October 3, 1980

Re: Nine Mile Point Unit 2
Docket No. 50-410

Your letter of July 9, 1980 requested additional information regarding geology at Nine Mile Point Unit 2. Enclosed are Niagara Mohawk's responses to questions Q361.26 through Q361.35 contained in the enclosure to your letter.

FIGURE 361.34-6

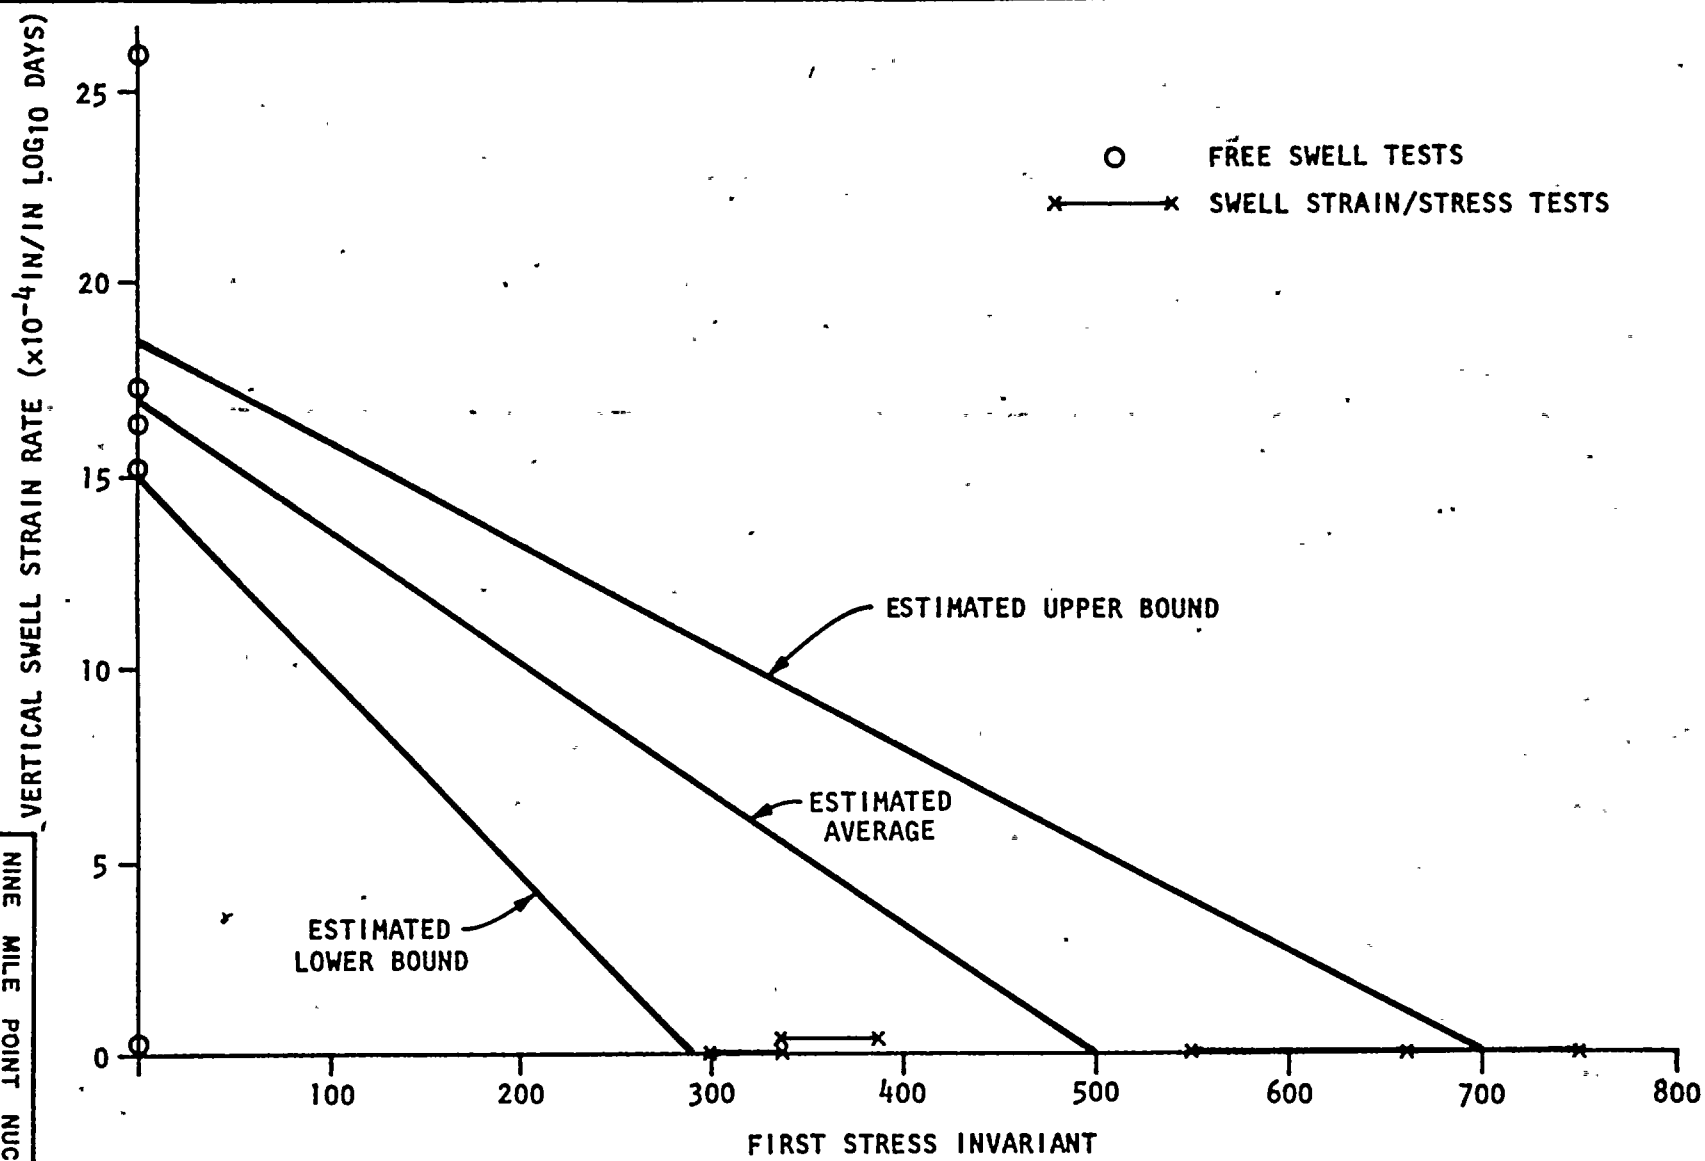
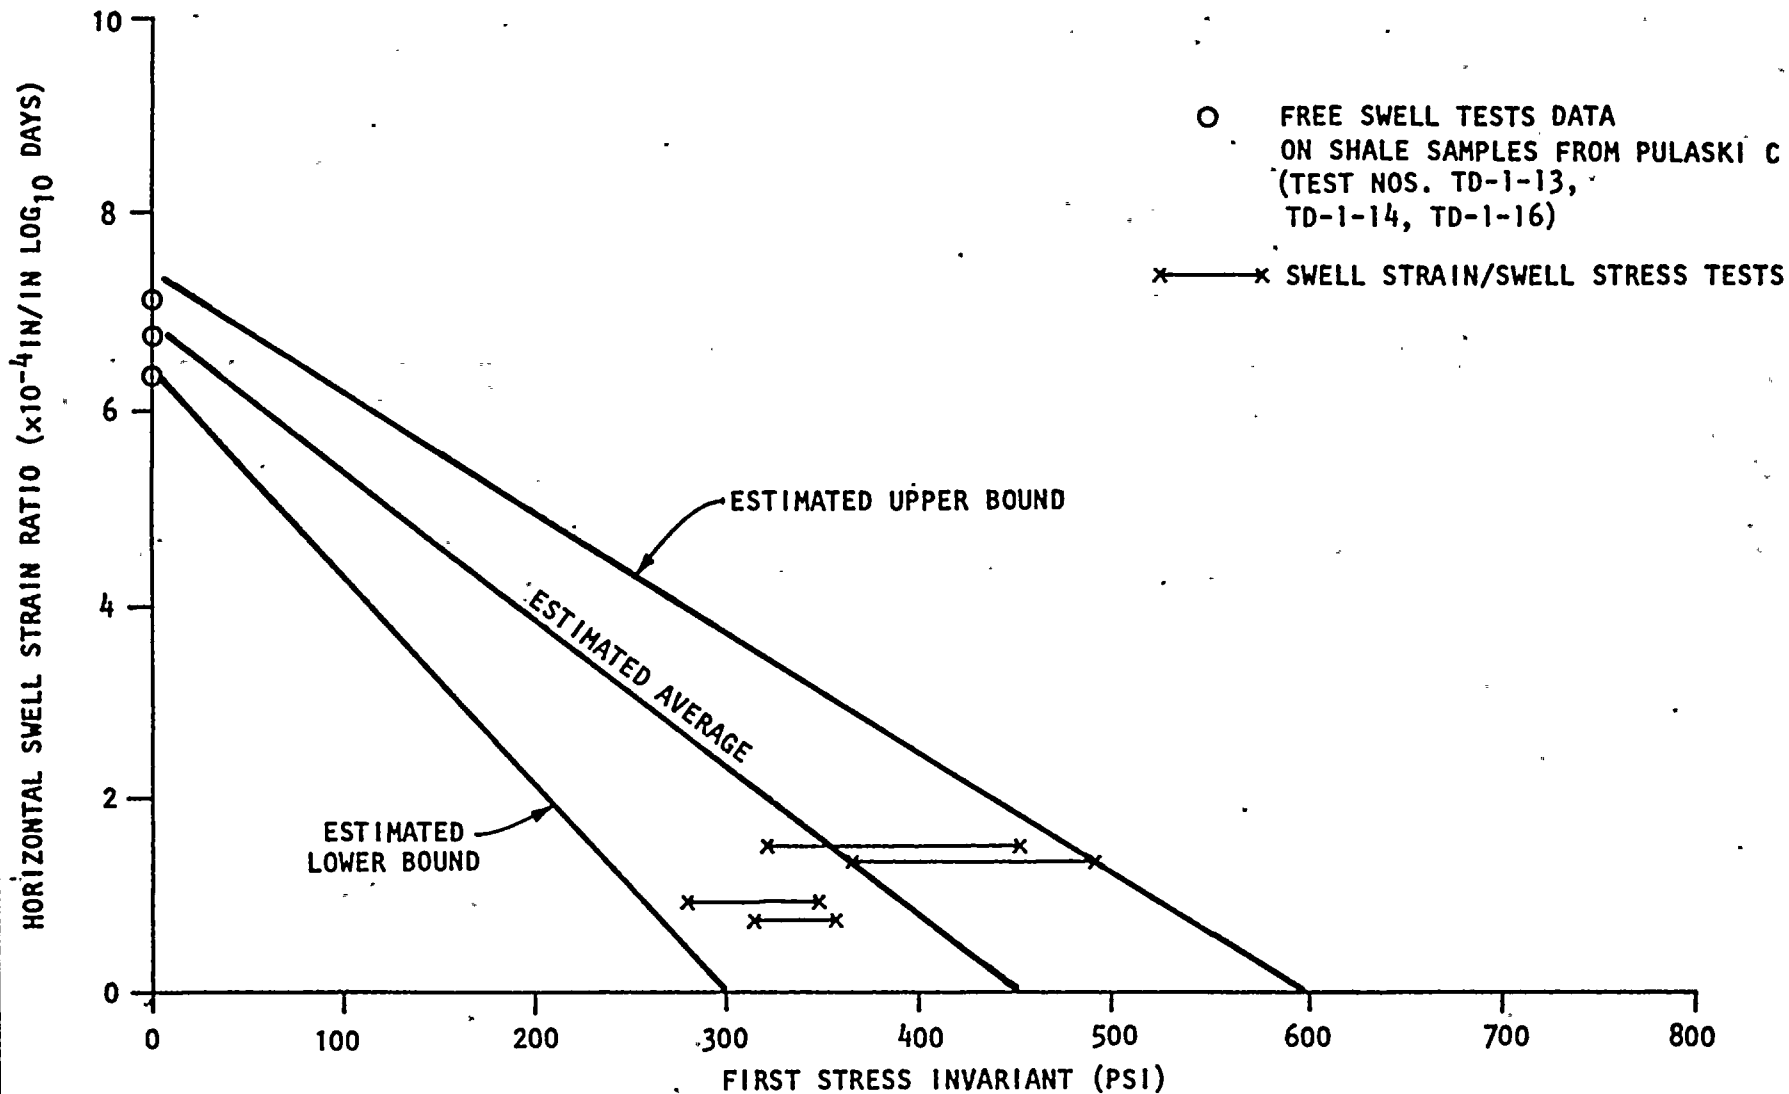
Q361.34 Substantiate the argument presented in Section 2.6 of your Summary that swelling stresses may have resulted from fluctuations in water level in Lake Iroquois. Show that rocks at the site can develop a swelling stress under confined conditions with water pressure varying from 1 to 10 atmospheres. Estimate how rapidly Lake Iroquois must have drained so that residual pore pressures could approach lithostatic pressures. In this evaluation, use the permeabilities determined by pumping test in the upper 200 feet of rock in this area.

The results of the oedometer ring swell tests are presented on Figures 361.34-1 through 361.34-8. The Figures show the relations of the swell rates as a function of the first stress invariant, which is the sum of the principal stresses. The rock units within which the Cooling Tower Fault is developed were tested for swelling potential. The following conclusions can be reached, based on the data presented:

- (i) the swell strain rates are dependent upon the first stress invariant. The rates decrease linearly with the increase of the stress invariant;
- (ii) there exists a limiting value for the first stress invariant beyond which swell rate is equal to zero. The limiting value indicated by the results appears to be larger than approximately 450 pounds per square inch (first stress invariant corresponding to hydrostatic pressure equal to 10 atmospheres).

Hence, it follows that rocks present at the site can develop a swelling stress under confined conditions with water pressure varying from 1 to 10 atmospheres. However, in order to develop these strains, the in situ bedrock stress must be reduced below the limiting value of the stress invariant. From observations of bedrock dilations onsite, it is clear that the required reduction occurred simultaneously with the deformation. The residual pore pressure may have been important in triggering this deformation.
